To: T10 SAS Protocol Working Group

From: Brian Day [and George Penokie](#)

Subject: ~~SAS-2.1~~[SPL](#): 08-249 Link Layer Power Management

This proposal is a complement to 08-015 [and 08-206](#). This proposal focusses on link layer changes to support lower power modes.

Figure 118 — SL (link layer for SAS logical phys) state machines (part 1)

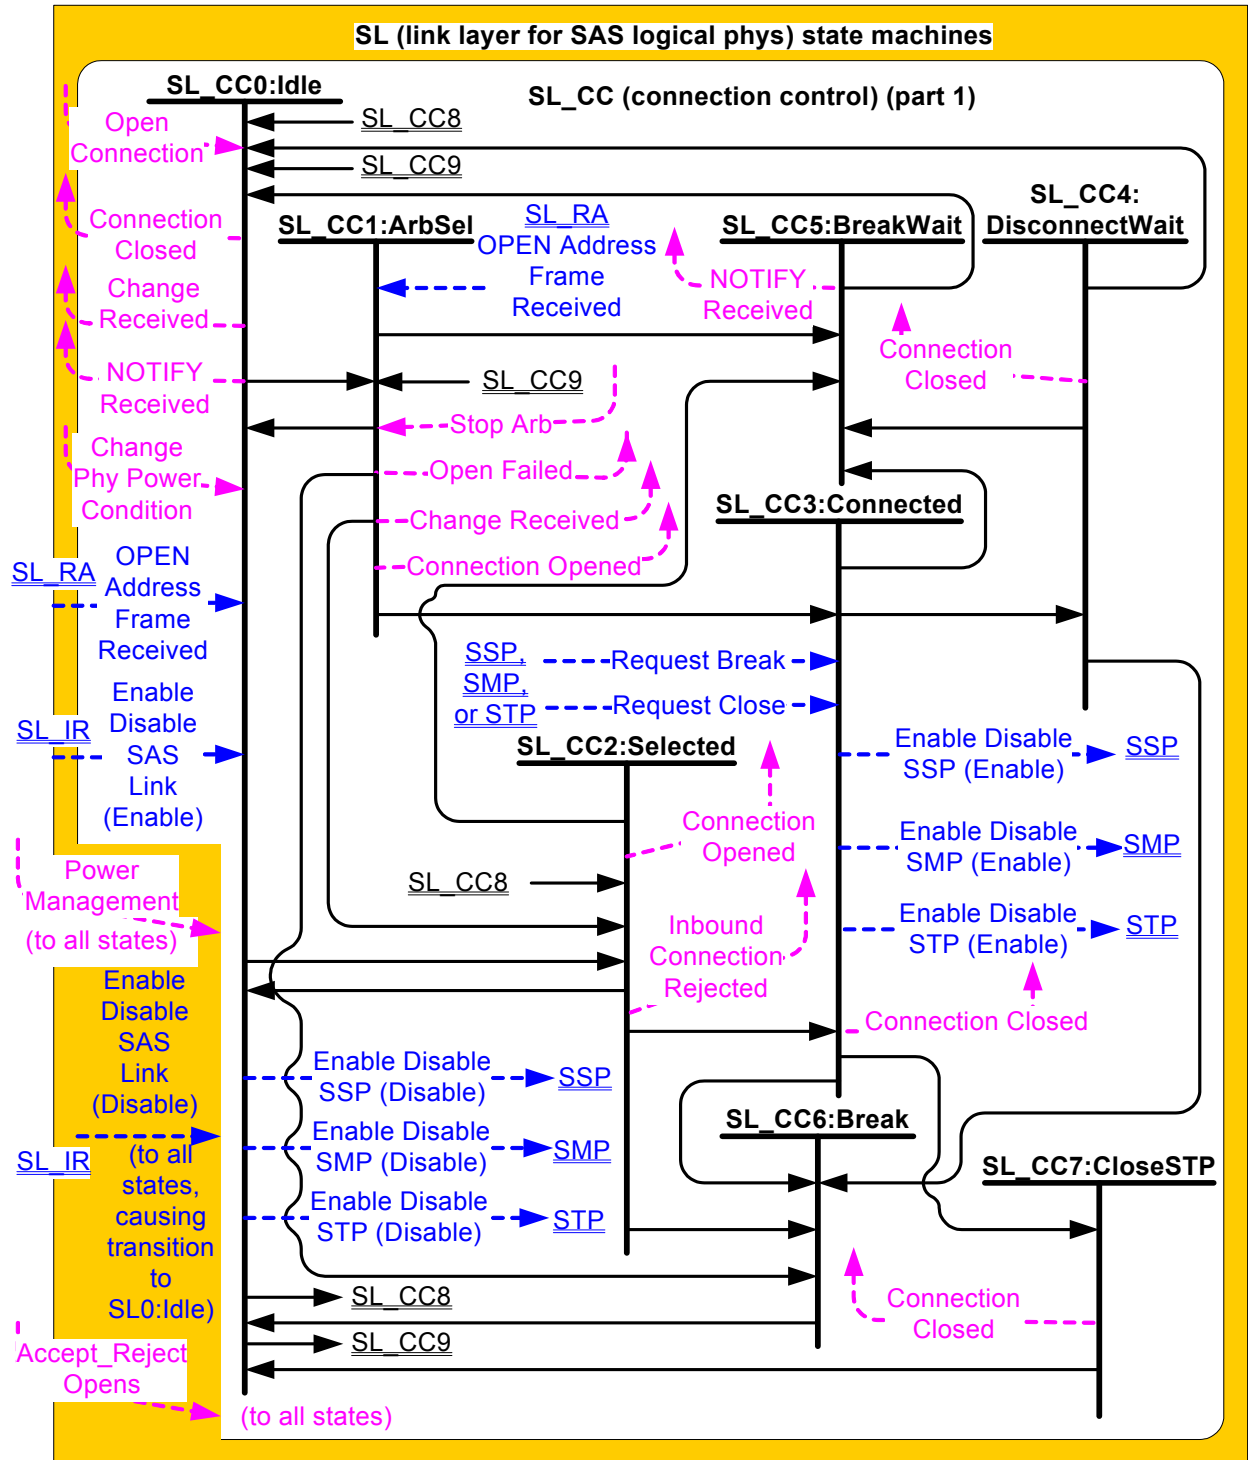
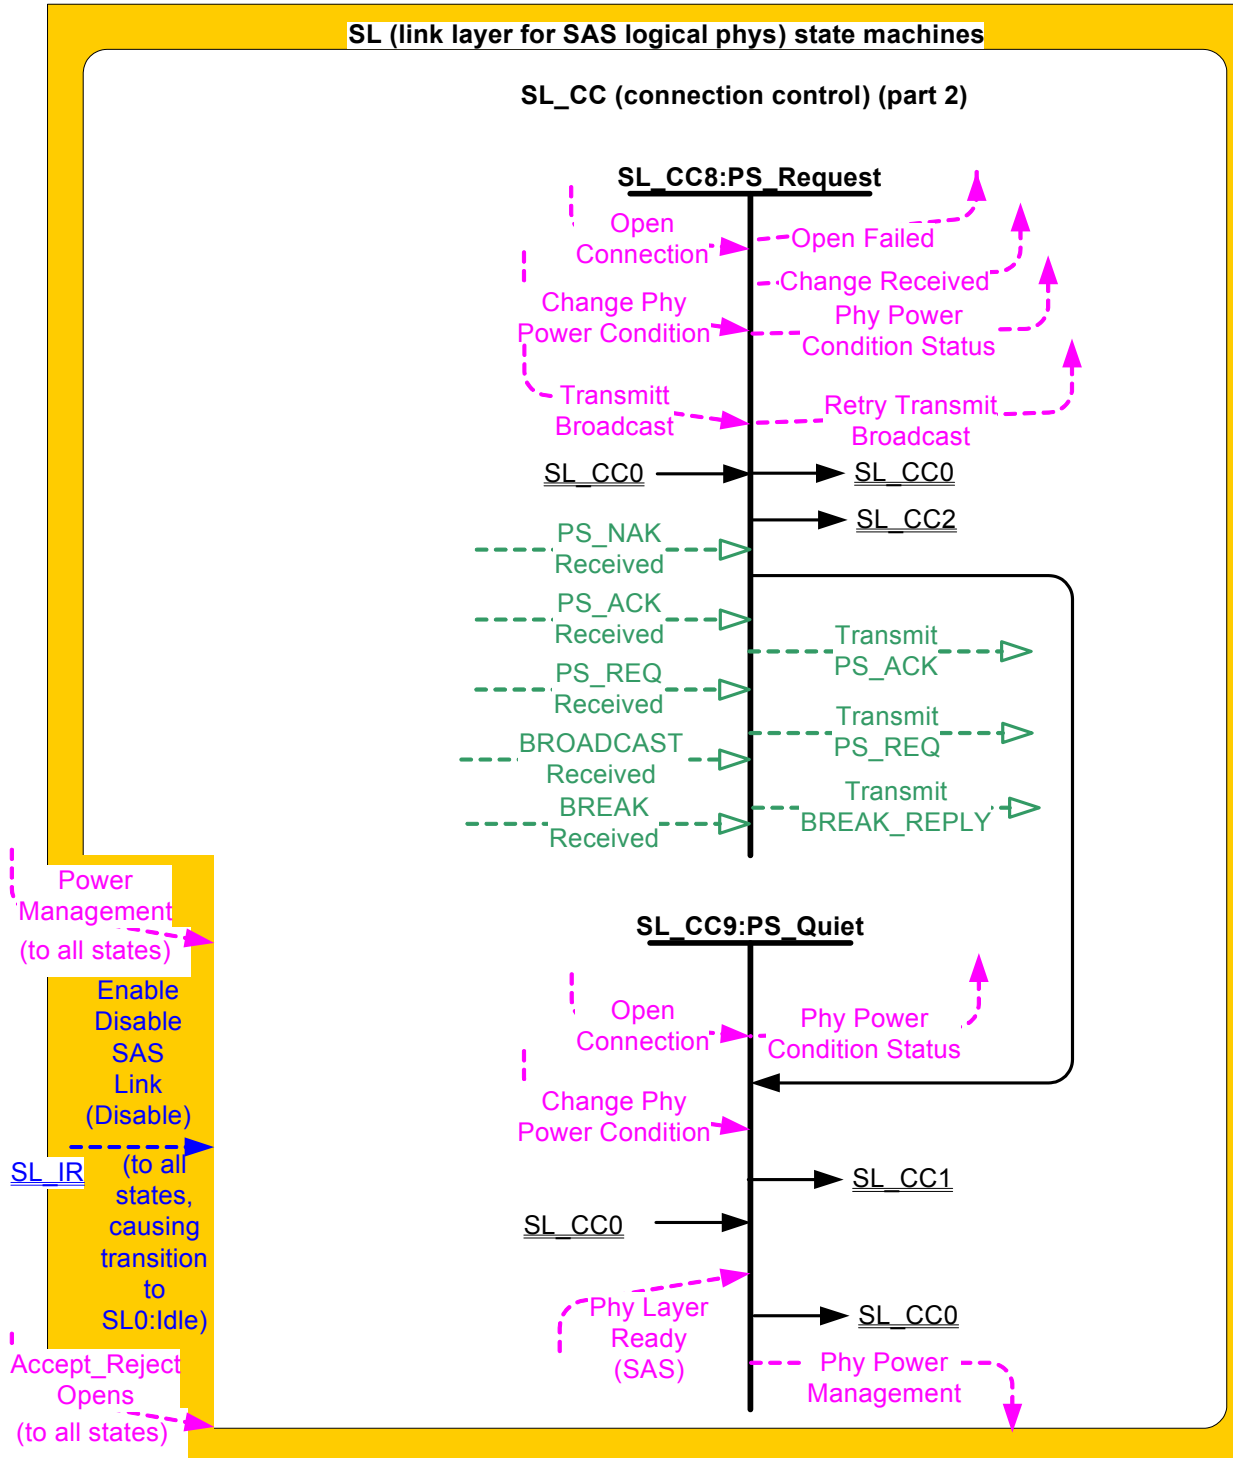
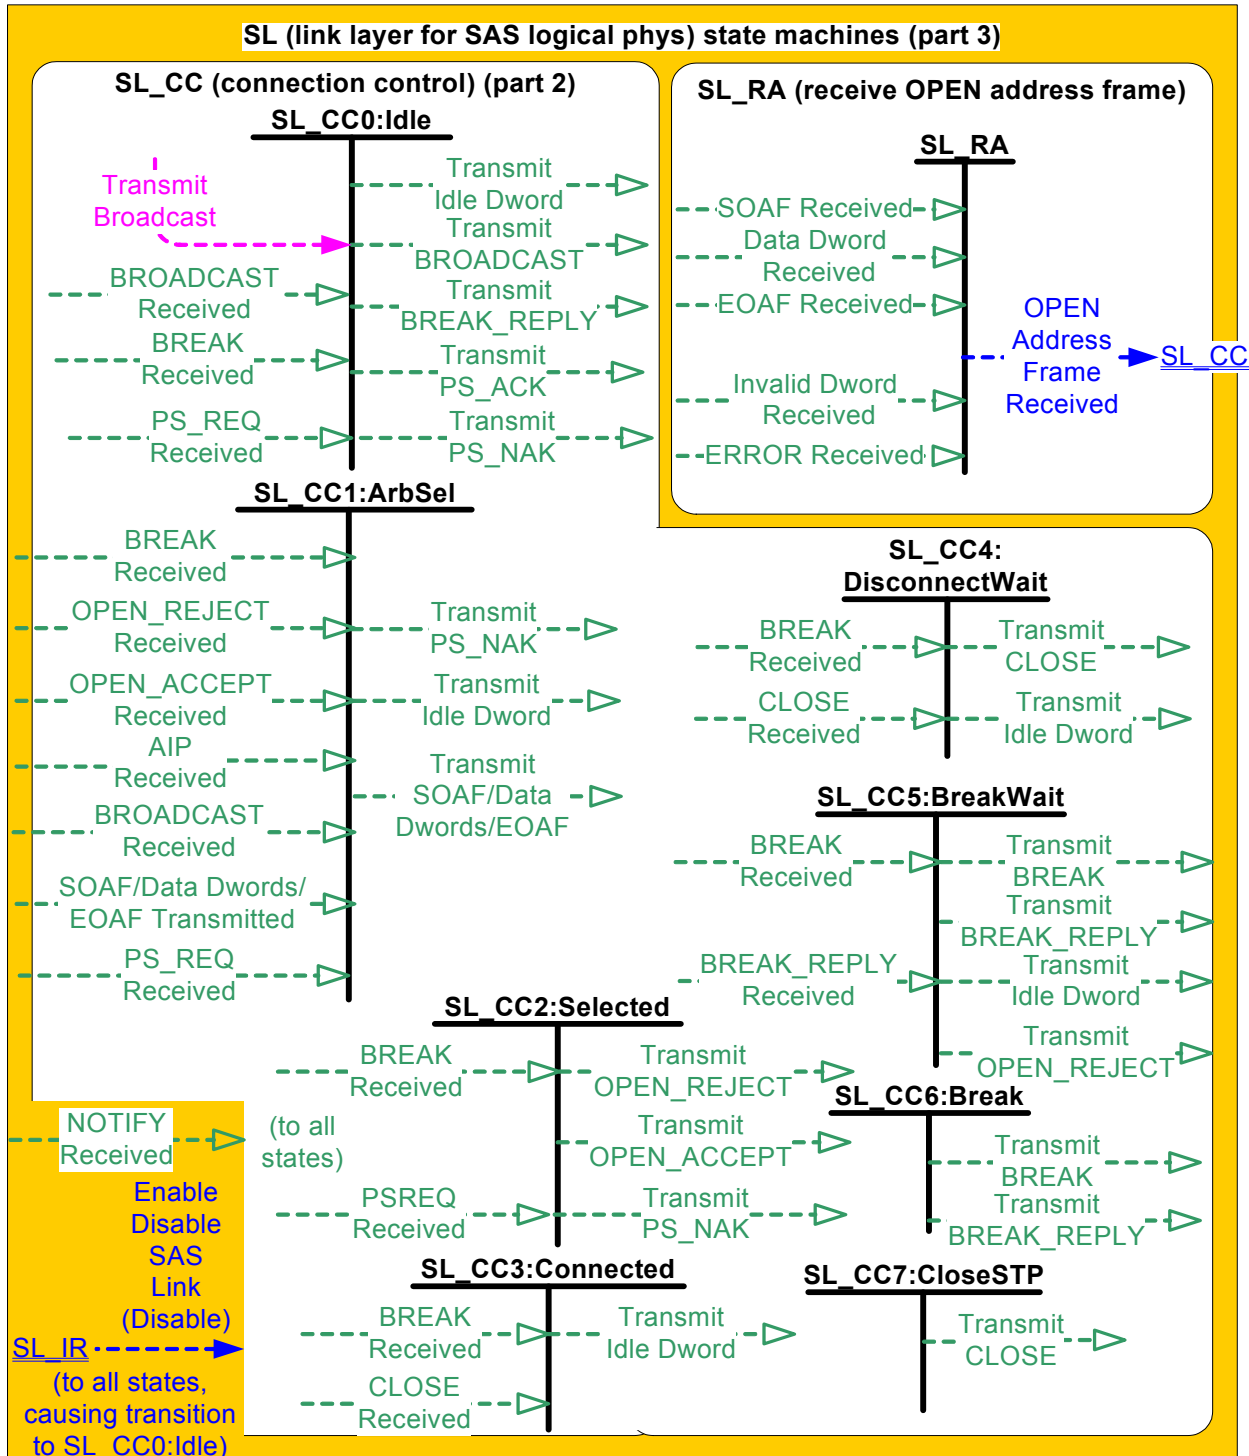
[Revision 2 - Added in the state machines for SL_CC, added in the definition for the manual moving between power conditions, and editorial changes from the September meeting.](#)

If a ~~PMREQPS_REQ Received (Partial)~~ message is received and ~~power management is enabled (see xxx)~~, the ~~Accept Partial~~ state machine variable is set to YES, then this state shall send a Transmit ~~PMACKPS_ACK~~ message to the SL transmitter. If a ~~PS_REQ Received (Slumber)~~ message is received and the ~~Accept Slumber~~ state machine variable is set to YES, then this state shall send a Transmit ~~PS_ACK~~ message to the SL transmitter. If a ~~PMREQPS_REQ Received (Partial)~~ message is received and ~~power management is not~~

If a ~~PMREQPS_REQ~~ Received message is received this state shall send a Transmit ~~PMNAKPS_NAK~~ to the SL transmitter.
